**DOCUMENT 00 90 00
ADDENDUM**

ADDENDUM NO. [1] Date: August 14, 2019

**RE: LANESBORO PUBLIC SCHOOLS
 ADDITION AND REMODEL
 100 KIRKWOOD ST EAST
 LANESBORO, MN 55949
 HSR 18063**

**FROM: HSR Associates, Inc
 100 Milwaukee Street
 La Crosse, WI 54603
 (608) 784-1830**

P121

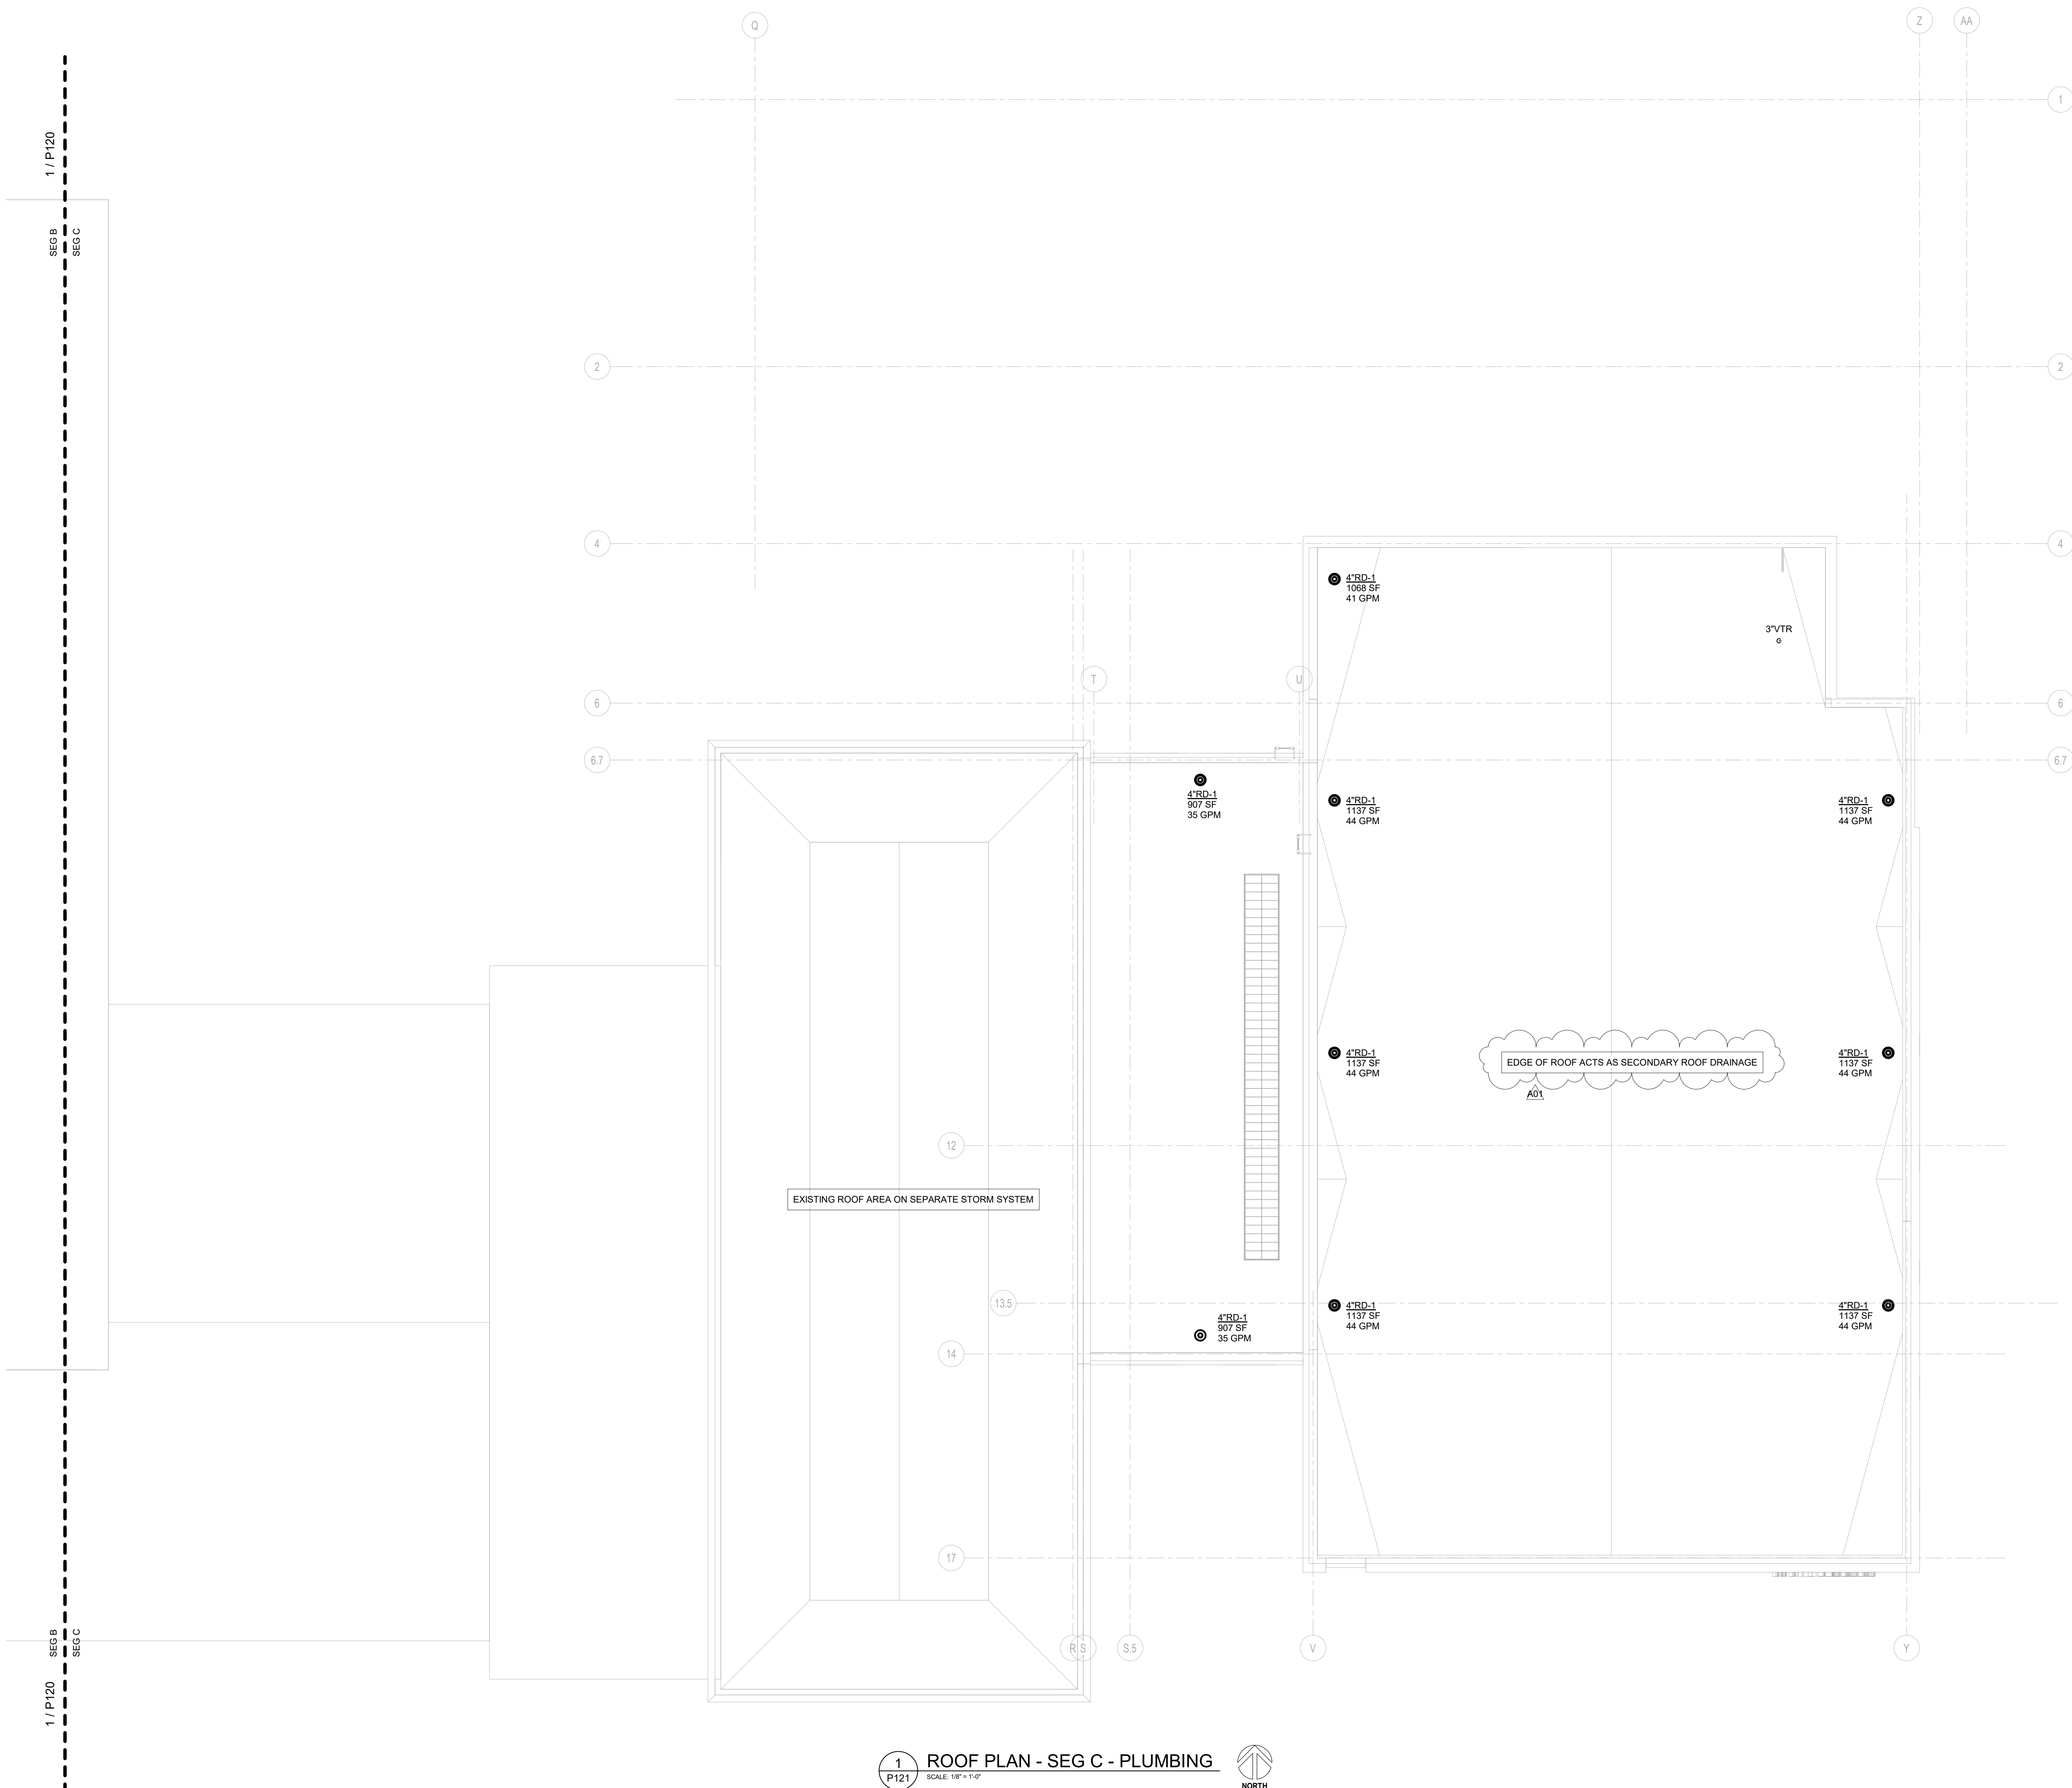
37. Sheet P120 ROOF PLAN – SEGMENT B - PLUMBING 30 x 42 attached hereto
 - a. Revisions clouded on Drawing.
 - b. Add notes, as shown.
38. Sheet P121 ROOF PLAN – SEGMENT C - PLUMBING 30 x 42 attached hereto

- a. Revisions clouded on Drawing.
 - b. Add notes, as shown.
39. Sheet P300 WASTE AND VENT ISOMETRICS - PLUMBING 30 x 42 attached hereto
 - a. Revisions clouded on Drawing.

P301

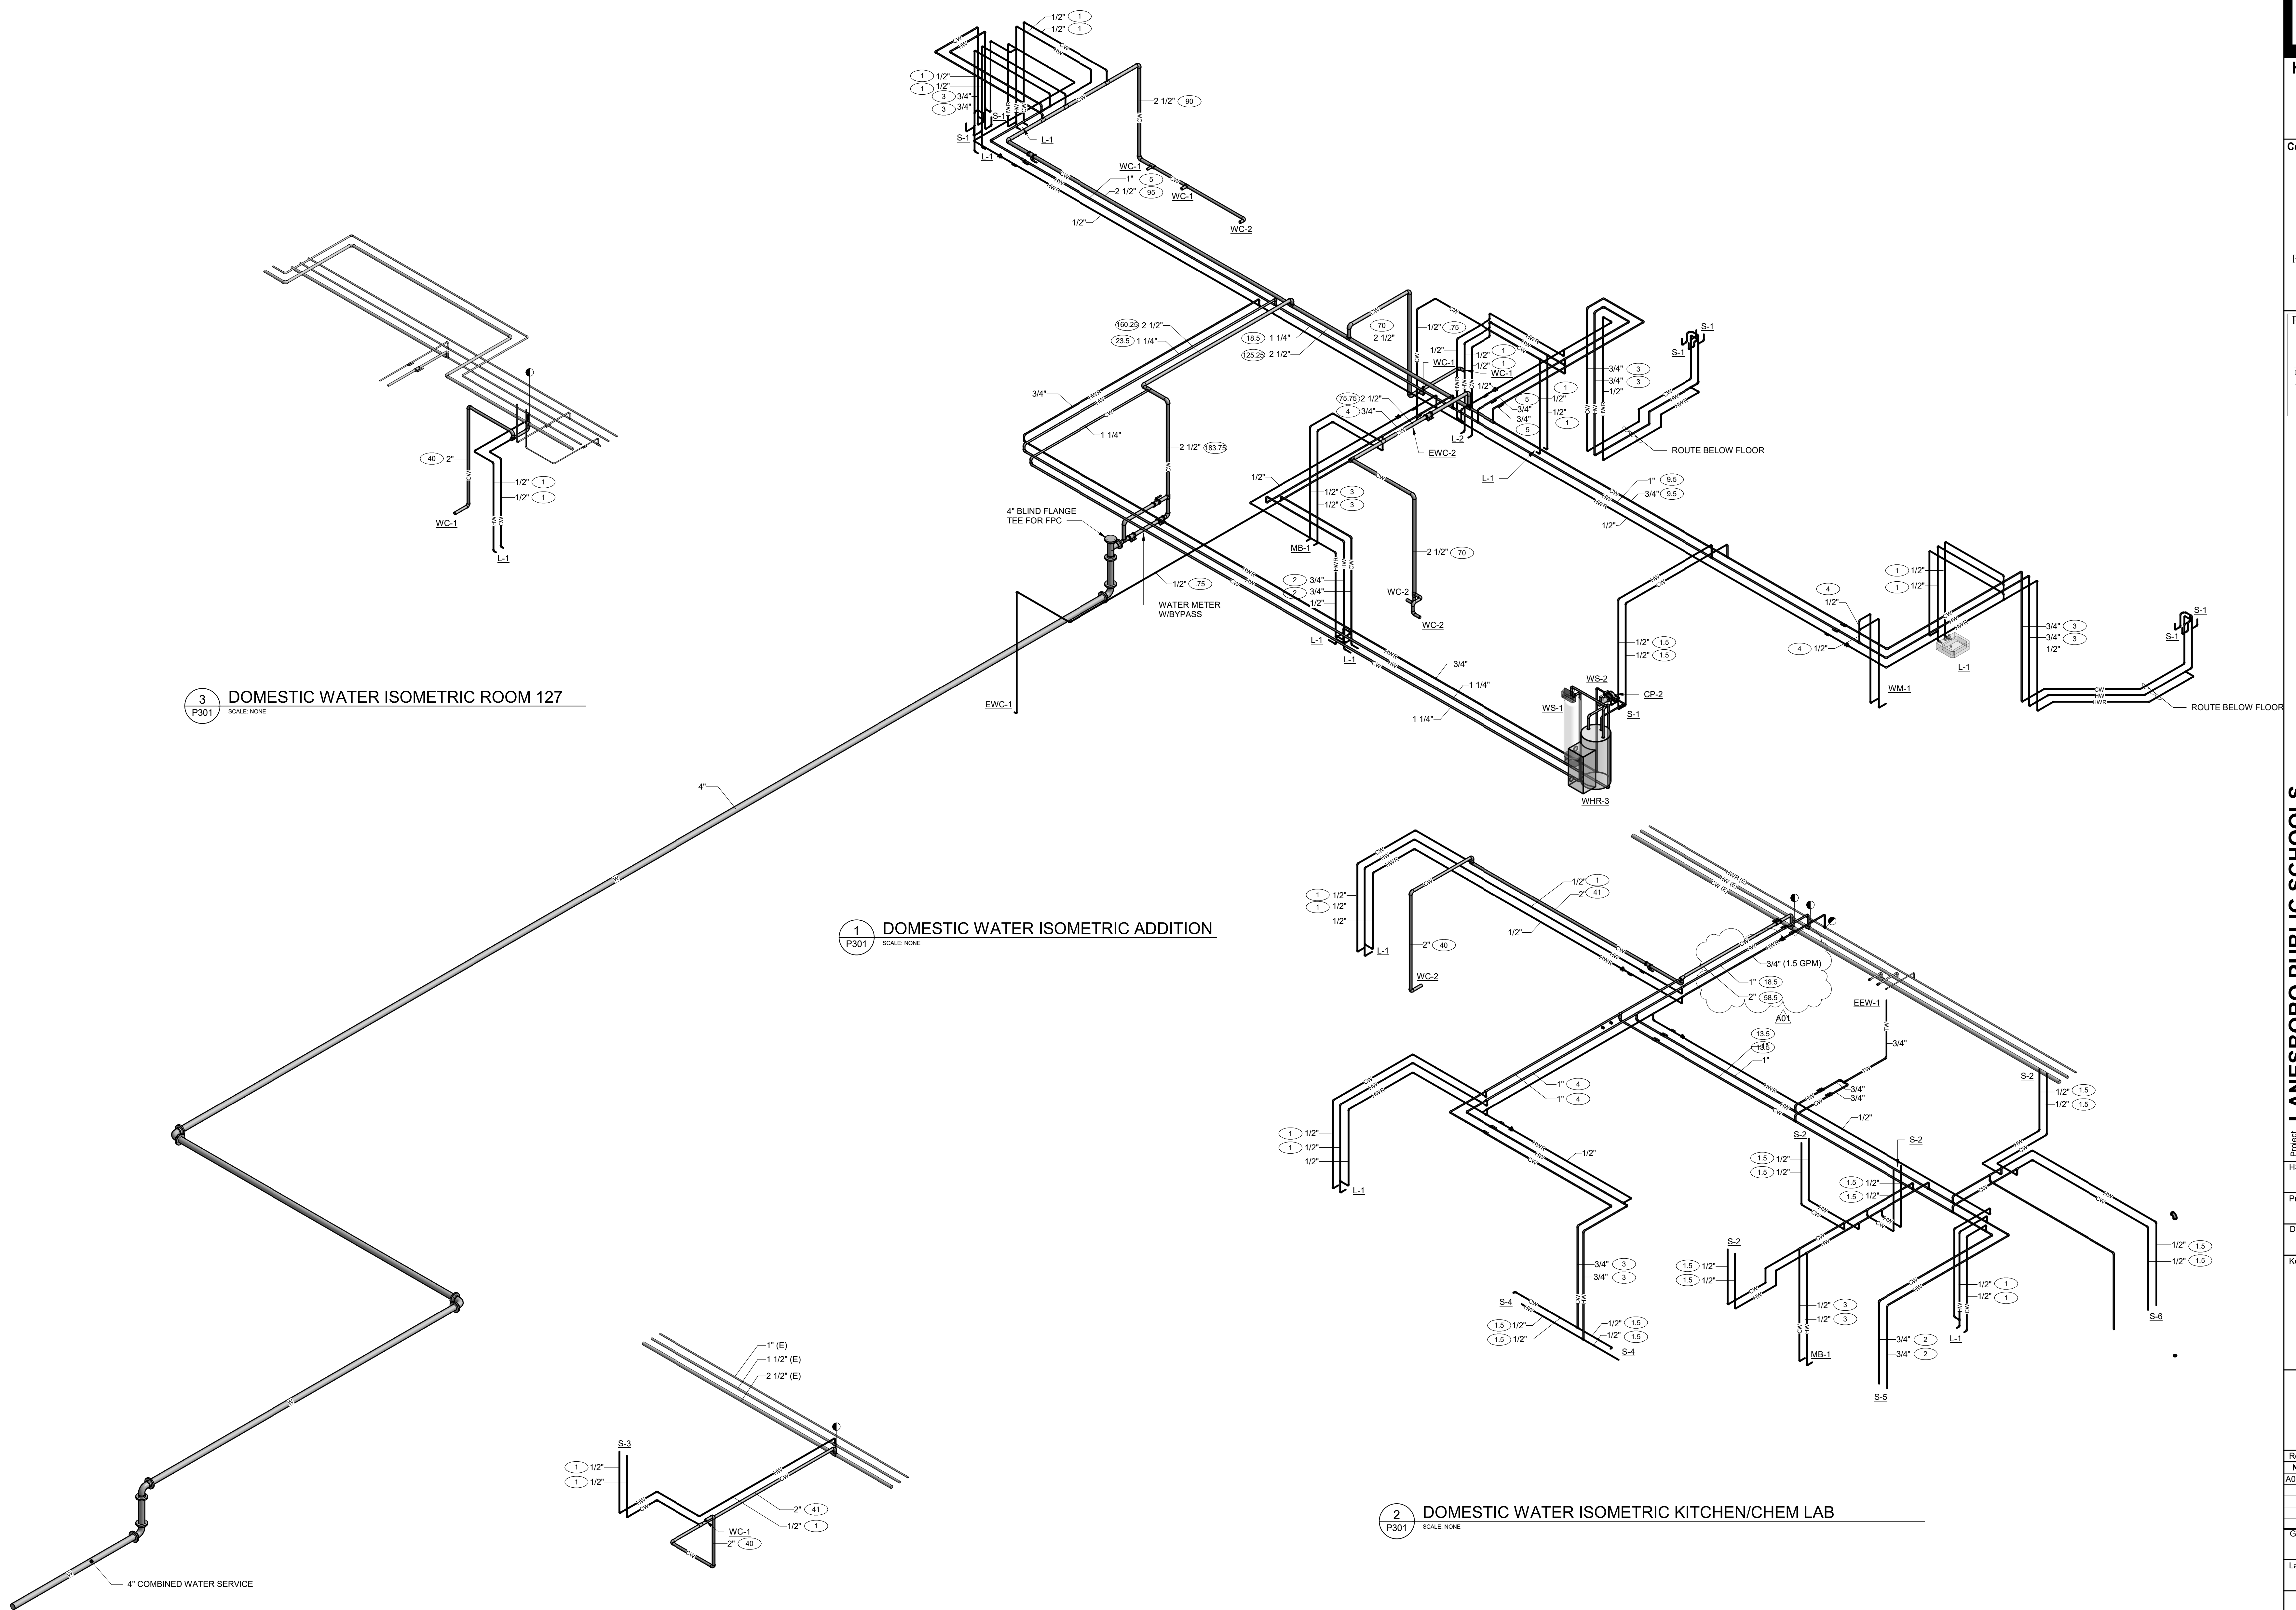
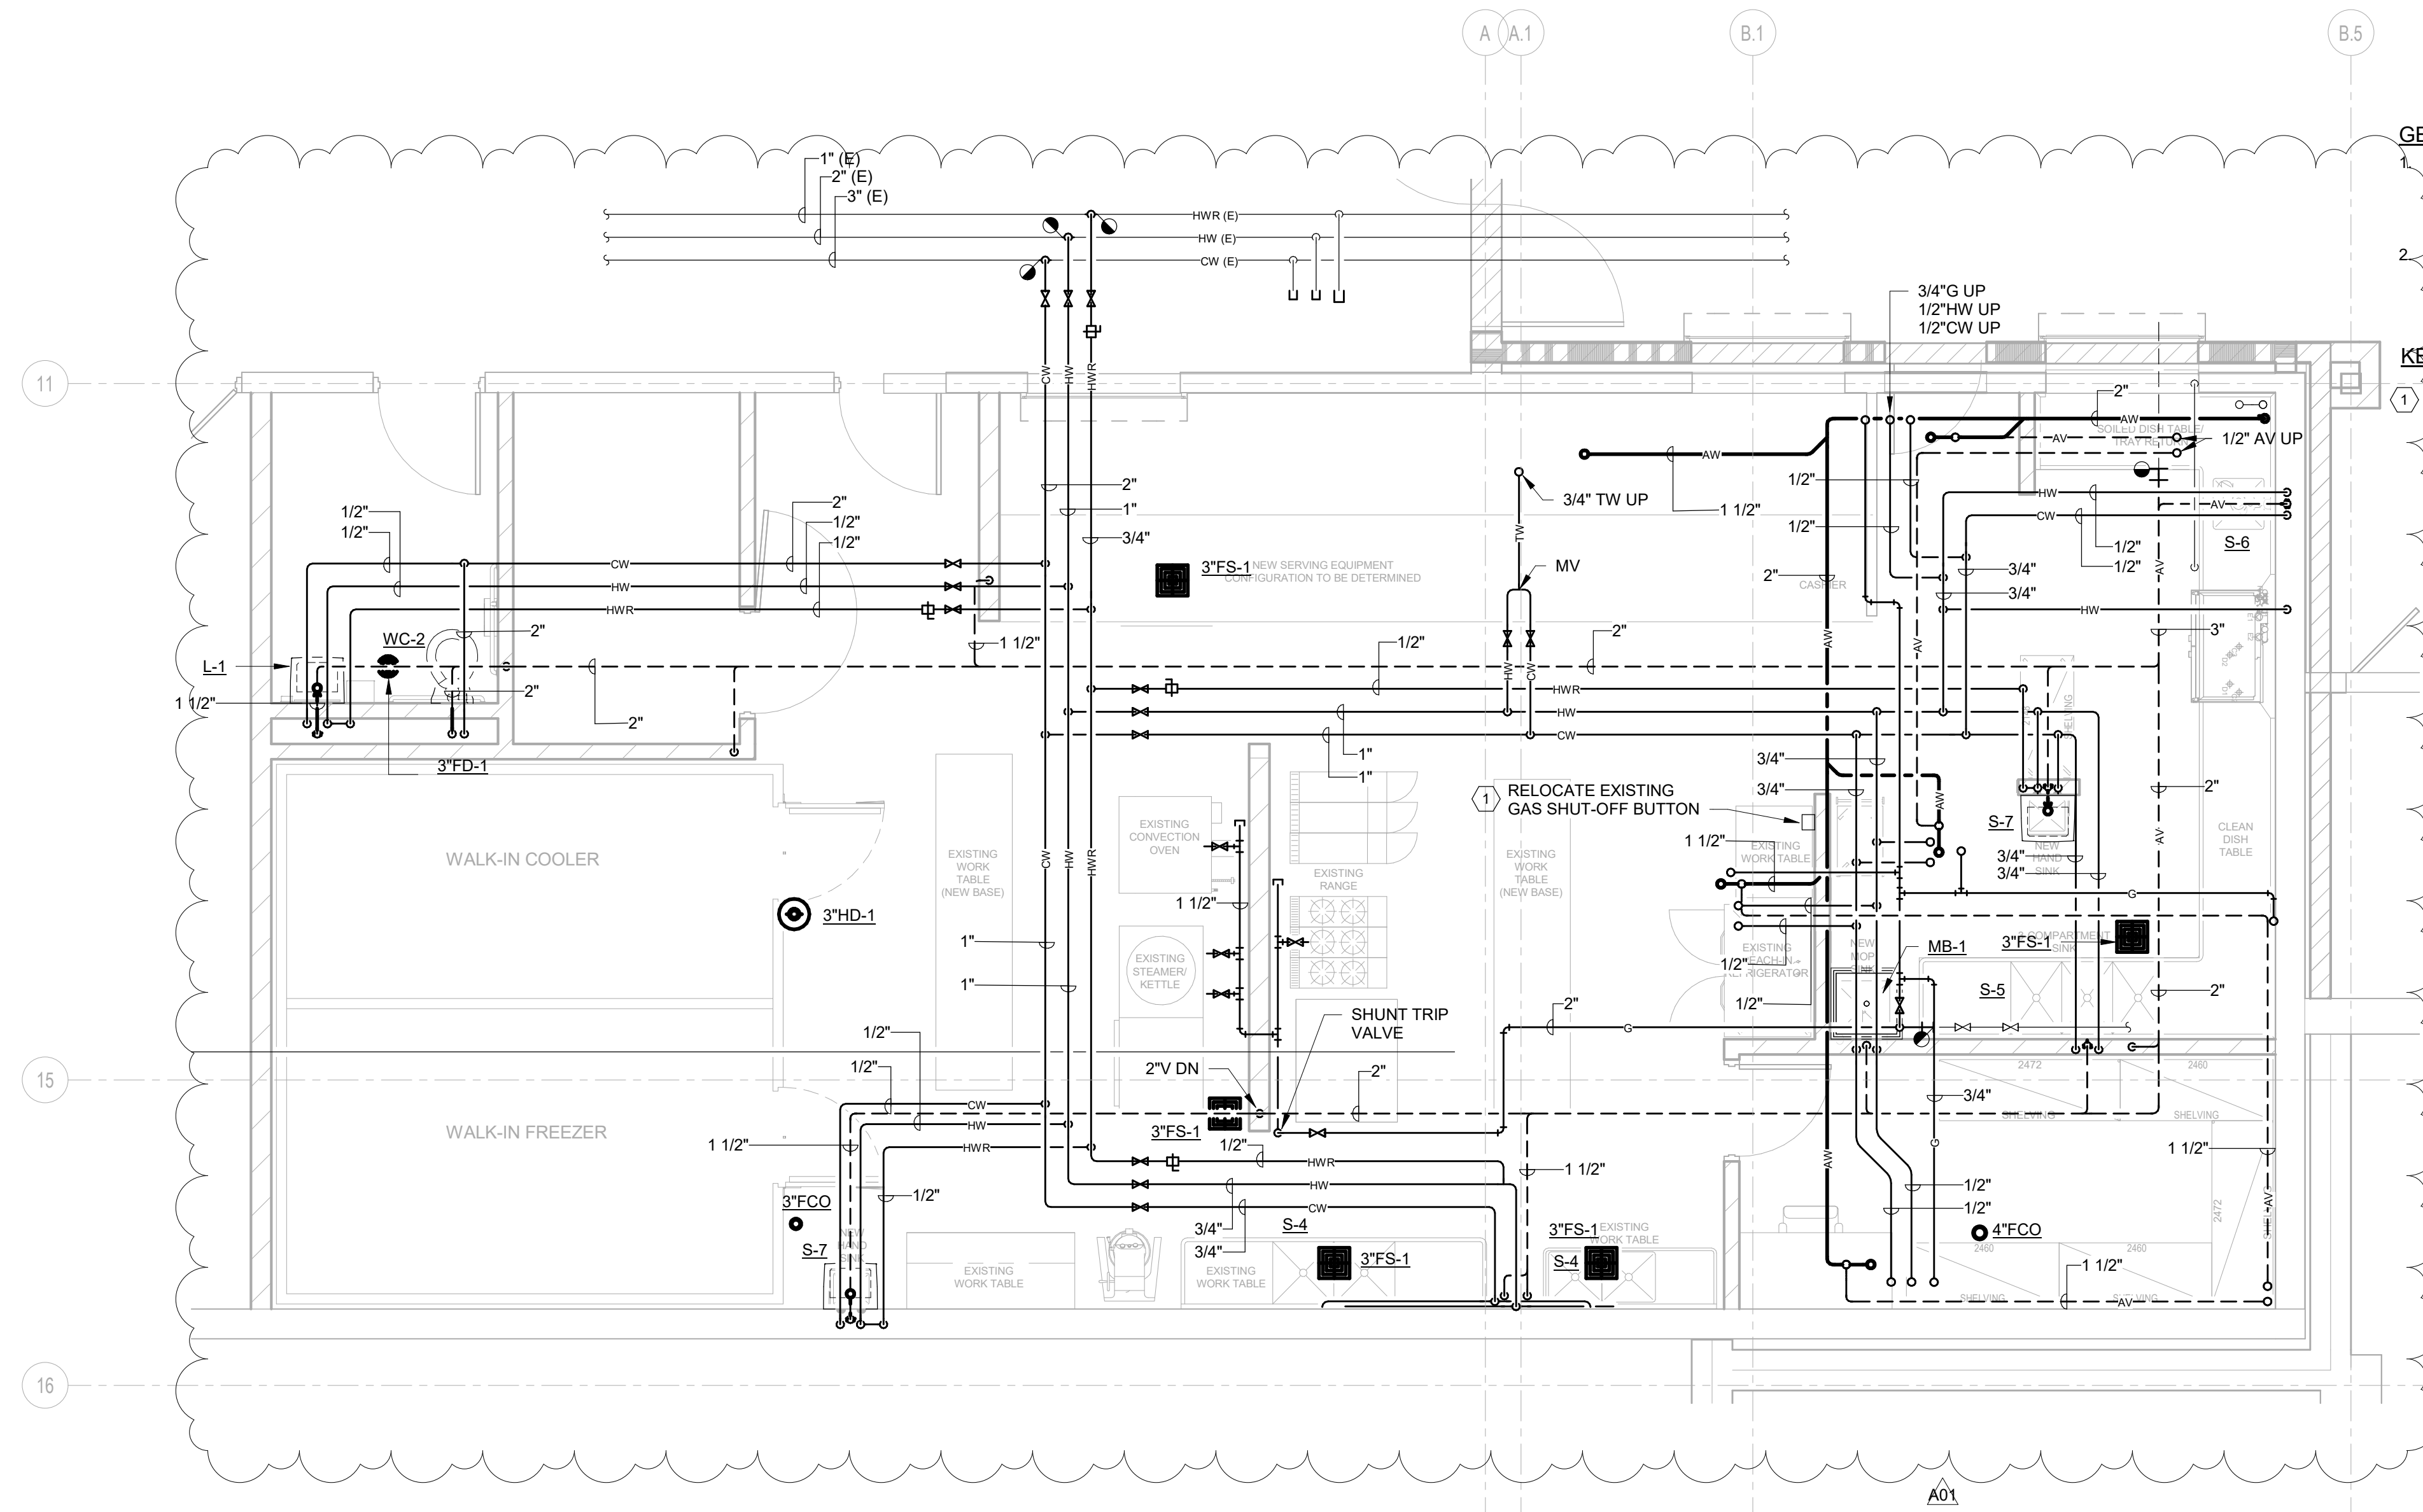
- b. Revise per floor plan changes, as shown.
40. Sheet P301 DOMESTIC WATER ISOMETRICS - PLUMBING 30 x 42 attached hereto
 - a. Revisions clouded on Drawing.

- b. Revise per floor plan changes, as shown.
41. Sheet P400 ENLARGED FLOOR PLANS – PLUMBING 30 x 42 attached hereto
 - a. Revisions clouded on Drawing.
